DOOSAN **Document Transmittal** Upper Trishuli-1 HEP (216MW)		Date 2022-06-08	DT No.: UT1-HEP-DHI-PC-D-0035	SHEET 1 OF 1
DOOSAN NEPAL BRANCH OFFICE	Address & Contact No. : Four Square Building, Naxal, Kathmandu, Nepal (P.O Box : 1387) + 977 1 692 3014	Project No. H20002	DOCUMENT DISPATCHED BY Courier Service ☐ Messenger ☐ Post-Air Freight ☐ Document System or E-mail ■ By hand ■	
DOCUMENT DISTRIBUTION	■ POWER CHINA (Subcontractor) ☐ Doosan's Site Office			
SUBJECT	Review Note RN-0136_Excavation and Support Drawings of Headrace Tunnel

REVIEW NOTE

Contractor	**Doosan Enerbility**		
Title of the Document	Excavation and Support Drawings of Headrace Tunnel		
Document No.	UT1-C-150-CVL-DC-54002	Revision	0A
Date of Documents	31.05.2022	Received Date	02.06.2022
Transmittal Form No.	UT1-HEP-DHI-D-0253		
Previous Review Date/Status	N/A	Prev. Review Note No.	N/A
Review Note No.	**RN-0136**	**Present Review Date**	**07.06.2022**
		Present Review Status	**AN**

Drawing No. UT1-C-150-CVL-DC-54002 (sh. 1/10), version 0A

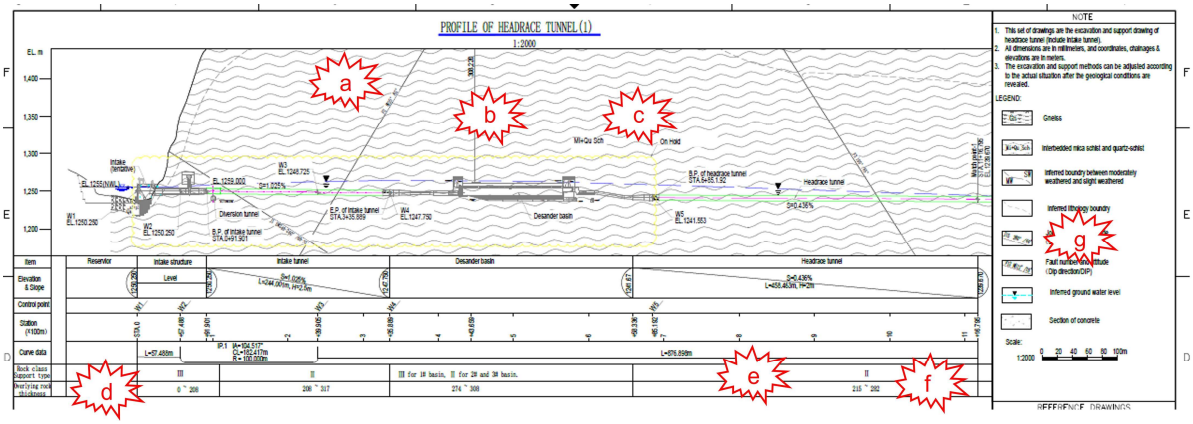
(a) Omit indicating faults where not been proven for certain.
(b) Clearly indicate the area where construction is on hold, exclude Diversion Tunnel.
(c) It is understood that the Contractor intends to continue with the Flushing Tunnel to reach – with the additional Connecting Tunnel, the HRT. Indicate.
(d) Provide in this and in respective sheets, drawings No. UT1-C-150-CVL-DC-54002 (sh. 2/10-5/10), version 0A, always the horizontal cover thickness at tunnel level. This is relevant to estimate potential water losses, if the tunnel liner will be perforated.
(e) Subdivide cover thickness in 100s of meters and the boundary where support in individual rock classes (here Class IV) changes.
(f) Revaluate excavation classes using the current knowledge from excavated tunnels.
(g) Revaluate entire geological legend using the current knowledge from excavated tunnels.

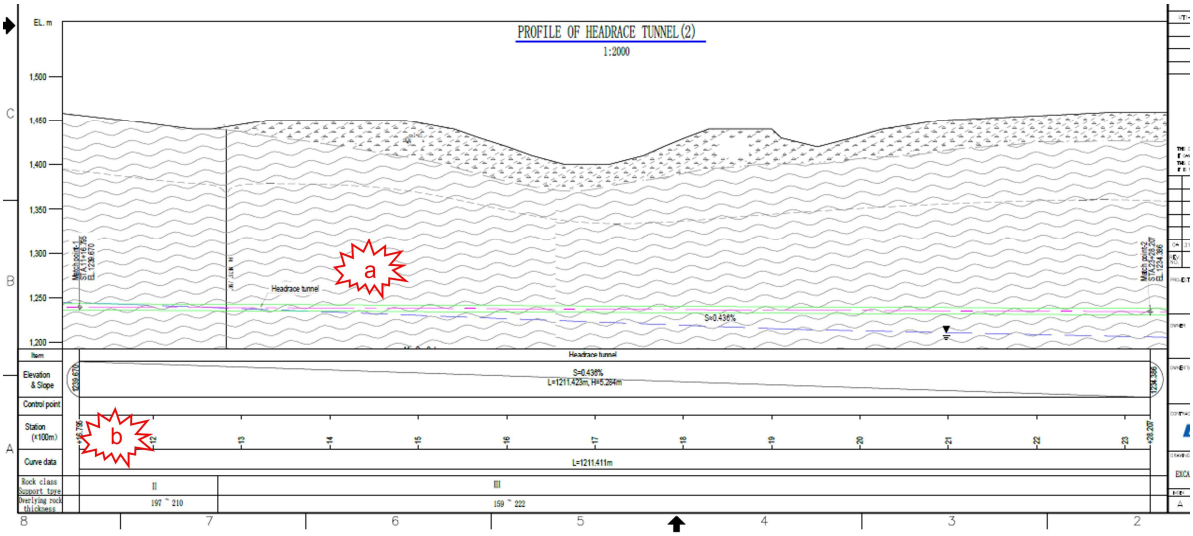
(a) As above under item (a).
(b) Update profile as above under items (e), (f) and (g).

Drawing No. UT1-C-150-CVL-DC-54002 (sh. 2/10), version 0A

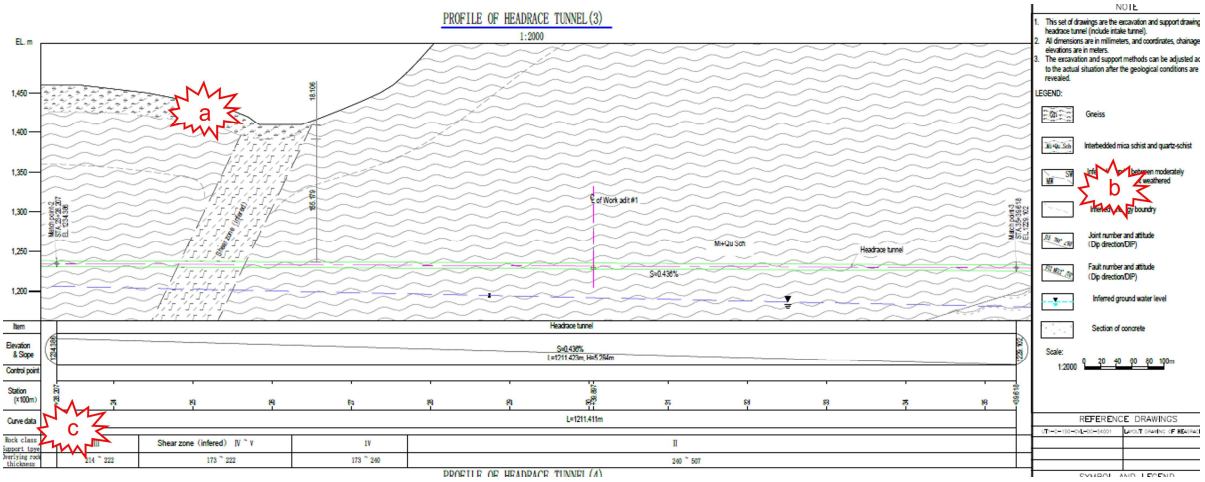
(a) Incorporate results of the refraction seismic investigations regarding the Haku Beshi Shear Zone.
(b) Update legend as requested for drawing No. UT1-C-150-CVL-DC-54002 (sh. 1/10), version 0A.
(c) Update cover thickness and overburden details as requested for drawing No. UT1-C-150-CVL-DC-54002 (sh. 1/10), version 0A.

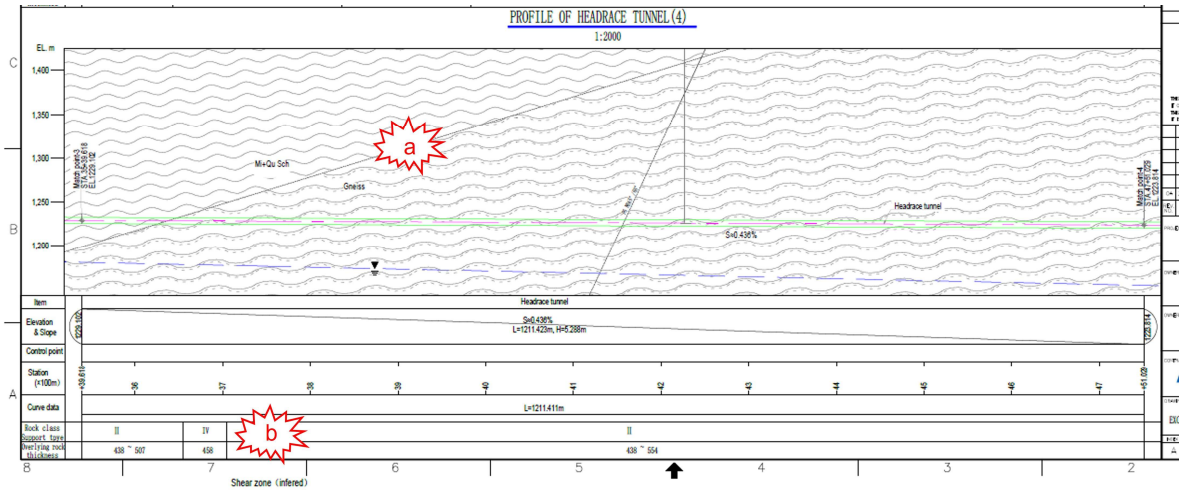
(a) Update geology and omit speculative faults.
(b) Update cover thickness and overburden details as requested for drawing No. Drawing No. UT1-C-150-CVL-DC-54002 (sh. 1/10), version 0A.

Drawing No. UT1-C-150-CVL-DC-54002 (sh. 3/10), version 0A

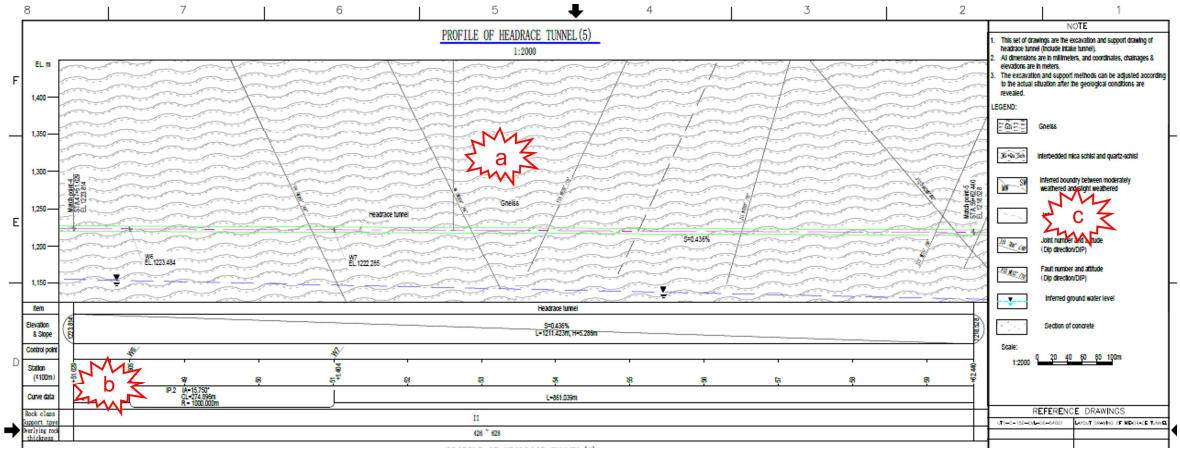
(a) Update as requested for drawing No. UT1-C-150-CVL-DC-54002 (sh. 1/10), version 0A.
(b) Update as requested for drawing No. UT1-C-150-CVL-DC-54002 (sh. 1/10), version 0A.
(c) Update as requested for Drawing No. UT1-C-150-CVL-DC-54002 (sh. 1/10), version 0A.

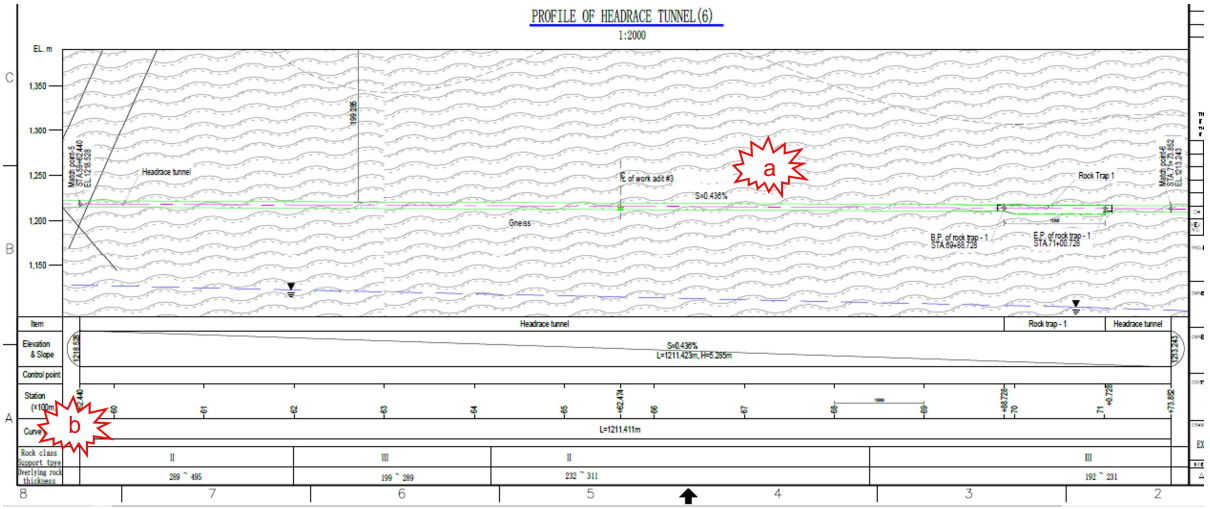
(a) Update as requested for drawing No. UT1-C-150-CVL-DC-54002 (sh. 1/10), version 0A.
(b) Update as requested for drawing No. UT1-C-150-CVL-DC-54002 (sh. 1/10), version 0A.

Drawing No. UT1-C-150-CVL-DC-54002 (sh. 4/10), version 0A

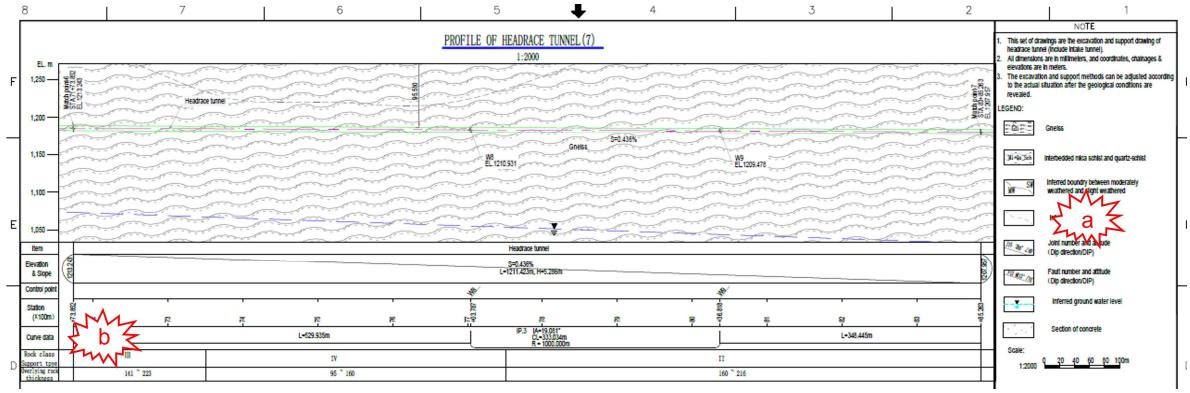
(a) Update as requested for drawing No. UT1-C-150-CVL-DC-54002 (sh. 1/10), version 0A.
(b) Update as requested for drawing No. UT1-C-150-CVL-DC-54002 (sh. 1/10), version 0A.

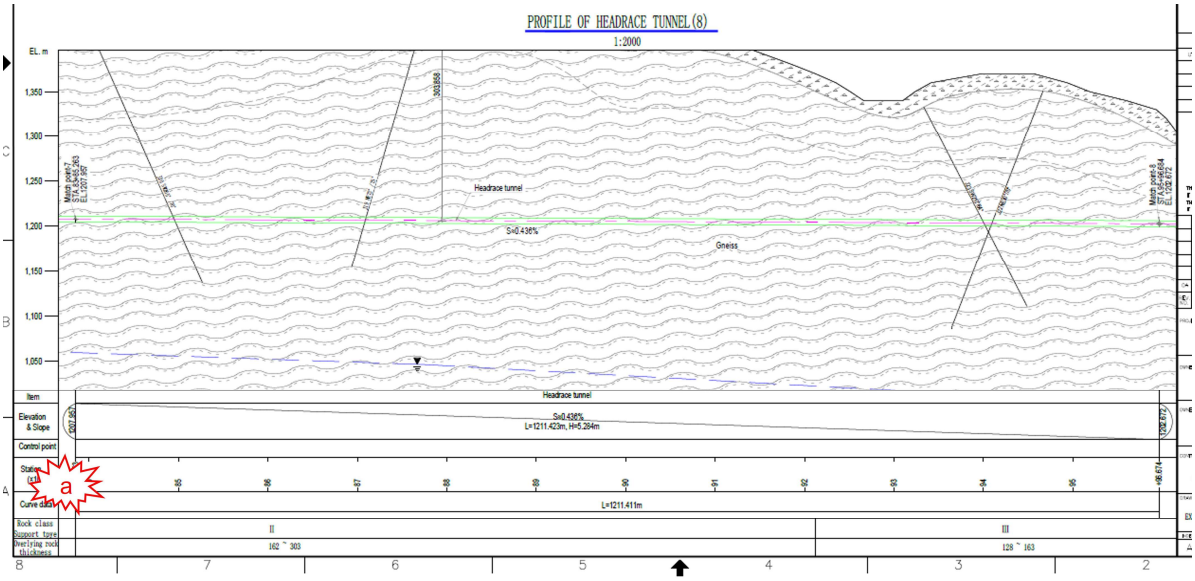
(a) Update as requested for drawing No. UT1-C-150-CVL-DC-54002 (sh. 1/10), version 0A.

Drawing No. UT1-C-150-CVL-DC-54002 (sh. 5/10), version 0A

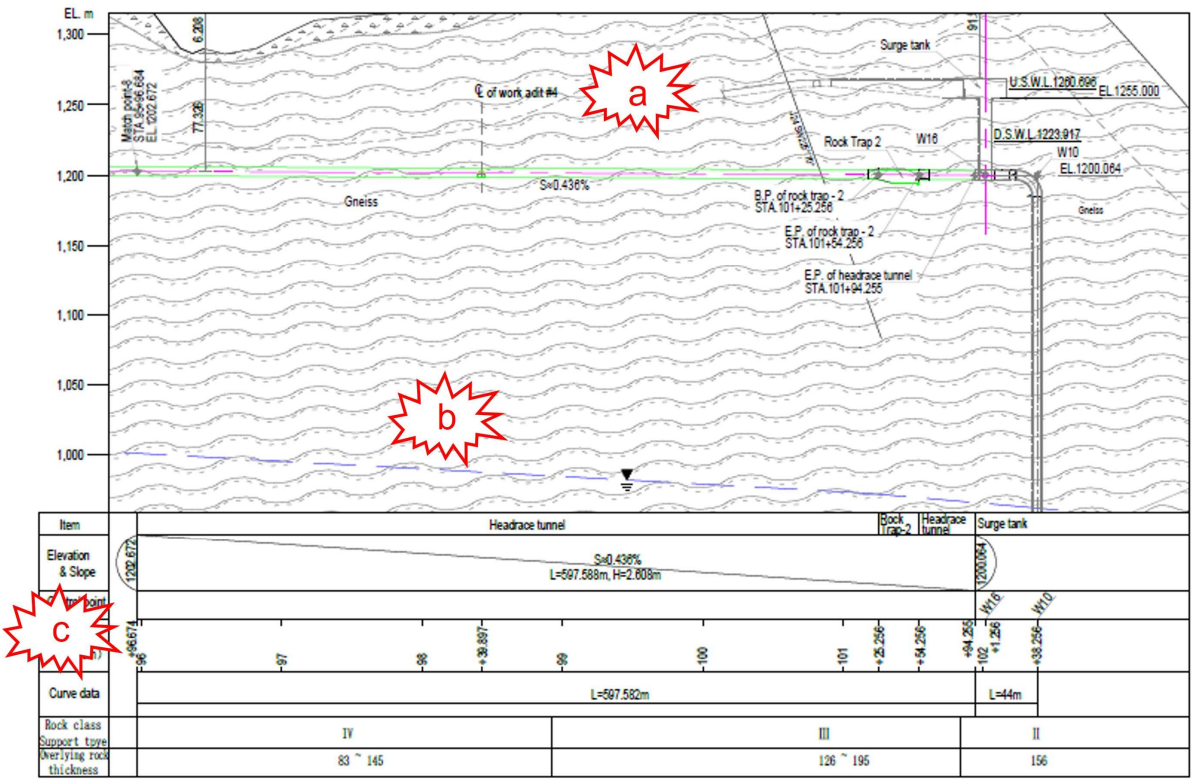
(a) Update with current layout of Surge Tank, if necessary.
(b) The groundwater table is certainly not expected at this level. Update with new knowledge on geology.
(c) Update as requested for drawing No. UT1-C-150-CVL-DC-54002 (sh. 1/10), version 0A.

(a) Orientation of discontinuities, if available from new data, shall be provided on the individual sheets along the alignment. Providing a summary as shown for the 10 km long alignment is inappropriate. Omit.
(b) Discontinuity strength data shall be provided in the Calculation Report - and justified, but not for the entire alignment of the 10 km long tunnel. Omit.

Drawing No. UT1-C-150-CVL-DC-54002 (sh. 6/10), version 0A

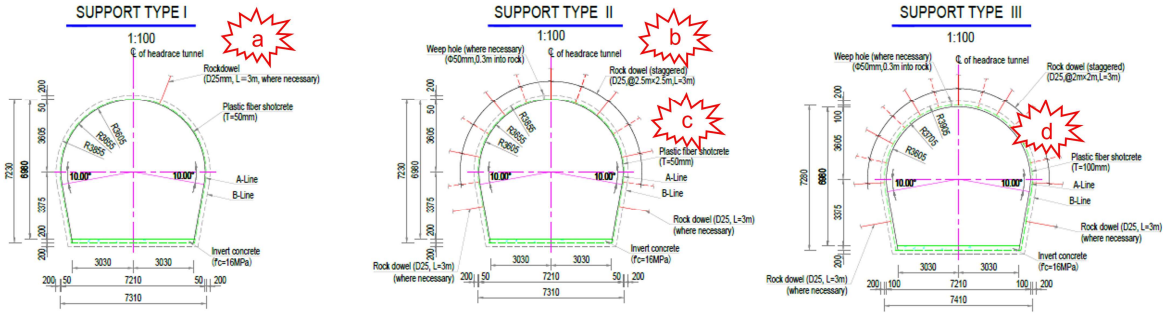
(a) No shotcrete liner in Class I rock. Replacement of strong and solid rock to comparatively weak shotcrete shall be avoided.
(b) Countercheck with waterway design assumptions ref weep-holes.
(c) 50 mm of shotcrete is certainly insufficient for a waterway with more than 7 m span. Revise.
(d) Consider appropriate thickness of shotcrete for Class III for this 7 m span waterway. Revise.

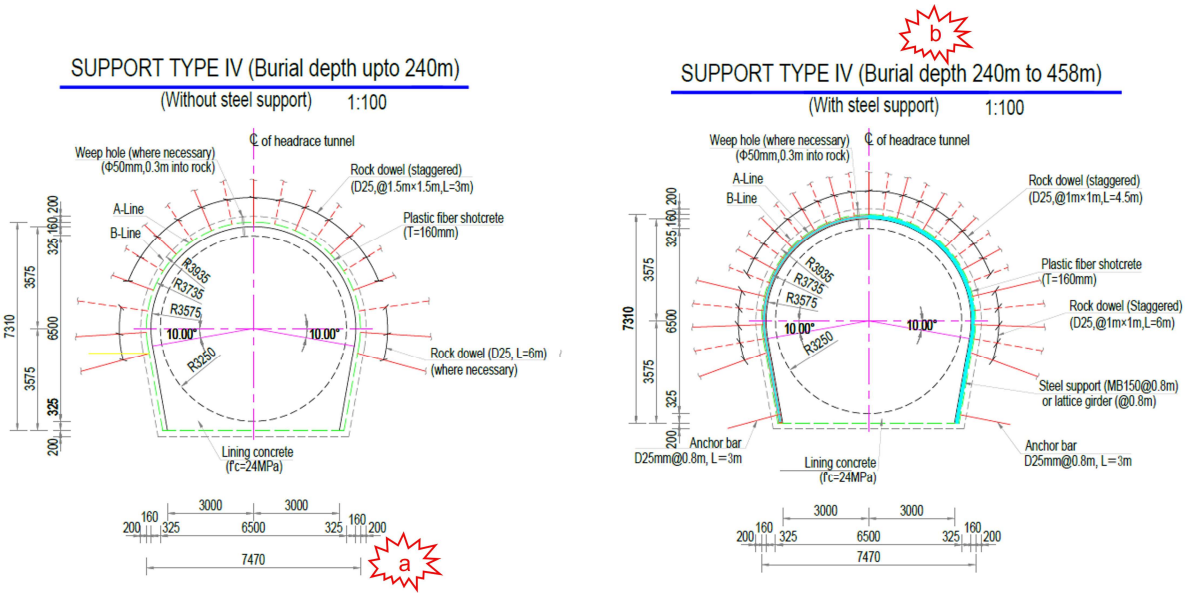
(a) With or without steel rib supported tunnel have same dimensions as shown. Steel rib must not be part of the reinforced concrete liner. Revise tunnel geometry, concrete and shotcrete thickness.
(b) Countercheck with tunnel longitudinal section regarding overburden. Specify TYPE IV for overburden thickness > 240 m.

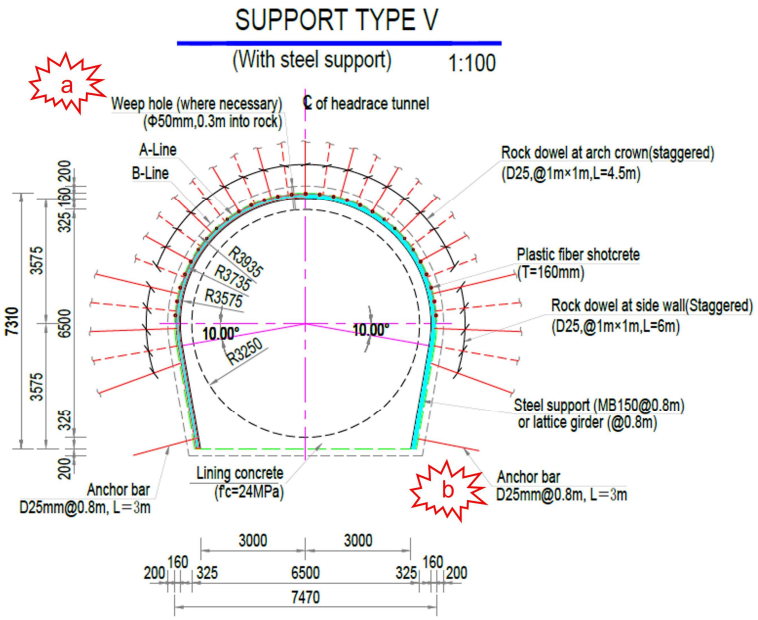
(a) Indicate consolidation / ground improvement measures.
(b) Indicate steel invert strut ("if necessary") and specify type of steel strut.

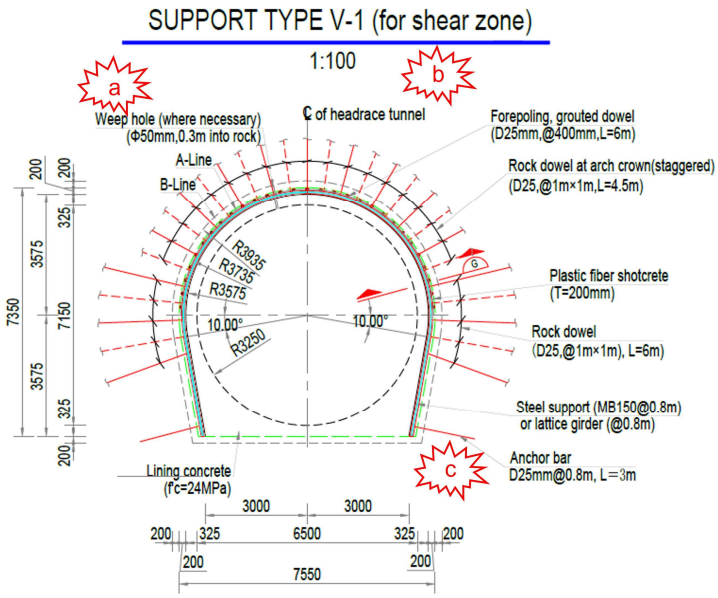
(a) Subdividing Classes V and Class V-1 may not be necessary. Consider.
(b) Detail ground improvement measures. Grouting, canopy tubes and other supplementary measures.
(c) Indicate steel invert strut ("if necessary") and specify type of steel strut.

Drawing No. UT1-C-150-CVL-DC-54002 (sh. 7/10), version 0A

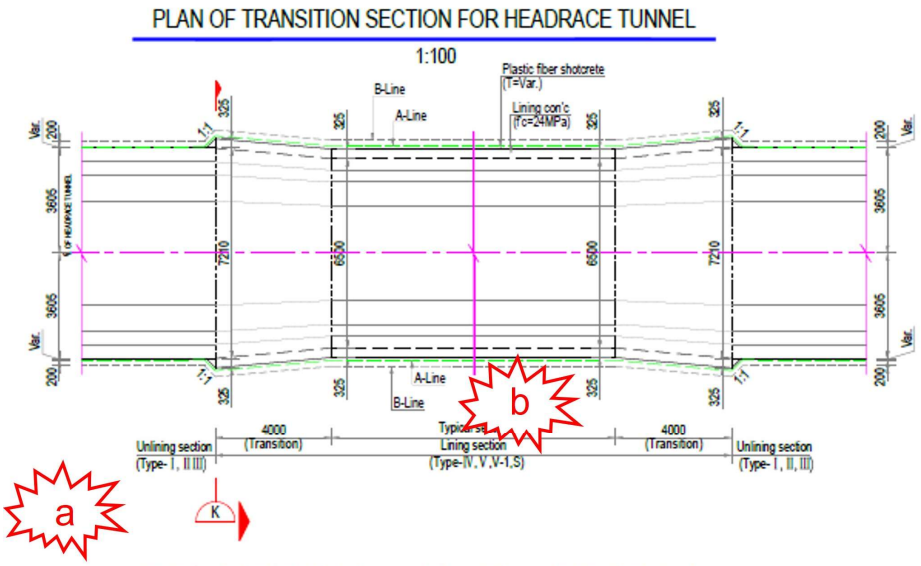
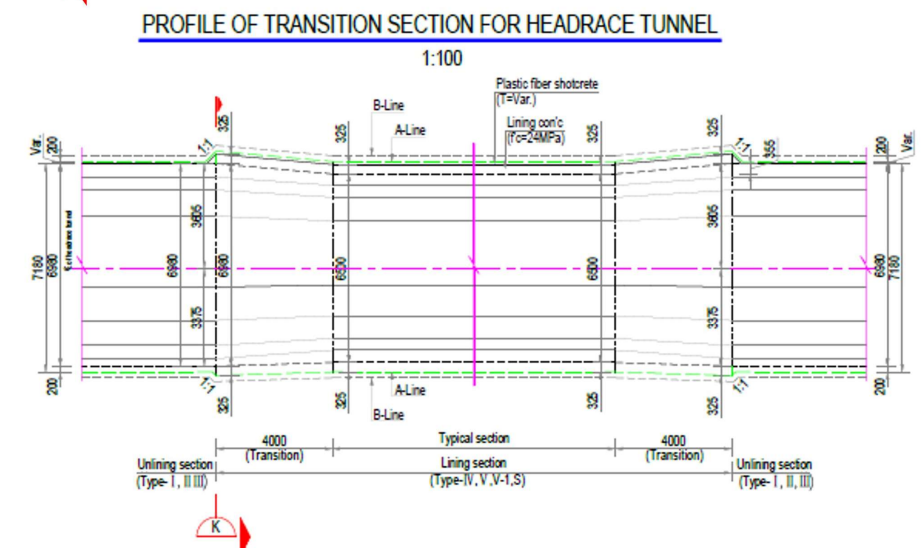
(a) Both drawings show the same geometrical layout and same content. Revise.

(b) Transition from 7.3 m dia shotcrete liner to 6.5 m dia concrete lined section may not be in compliance with hydraulic requirements. Countercheck.

(a) Update table.

(b) Update tunnel support.

Drawing No. UT1-C-150-CVL-DC-54002 (sh. 8/10), version 0A

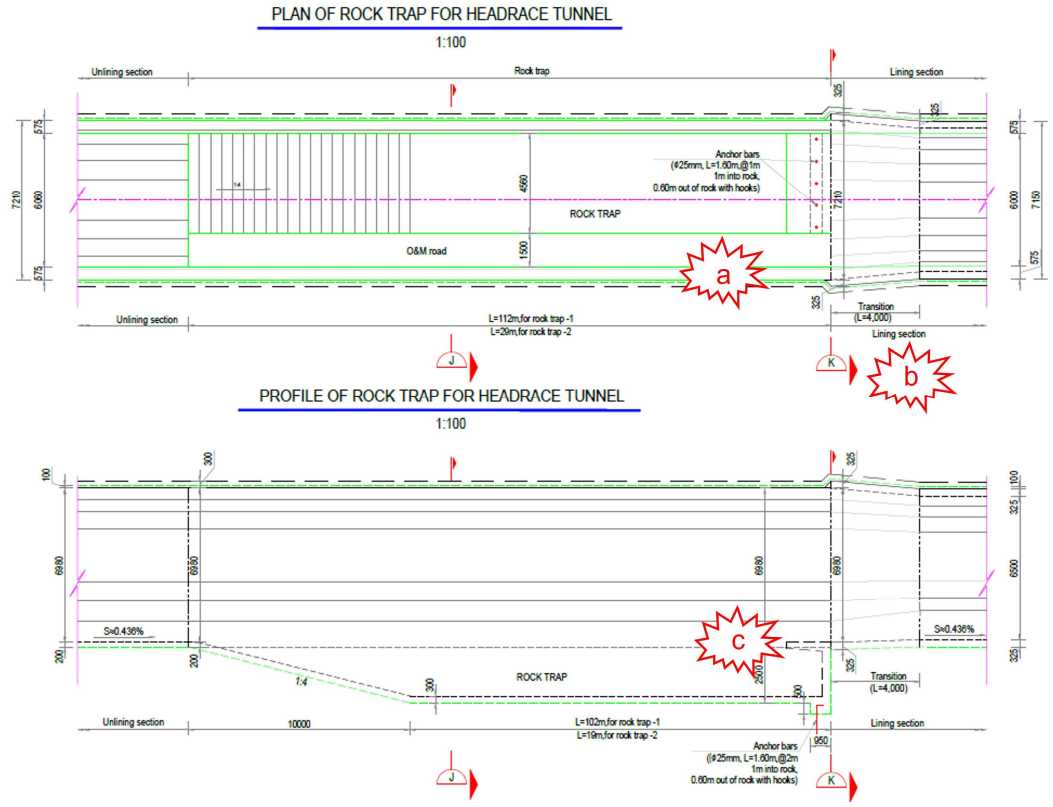
(a) Plan view shows O&M road going through the whole trap. Incorrect. Revise.
(b) Consider whether there is always a concrete lined tunnel section downstream of the trap. Also downstream Trap 1? Consider.
(c) As item (b). Consider.
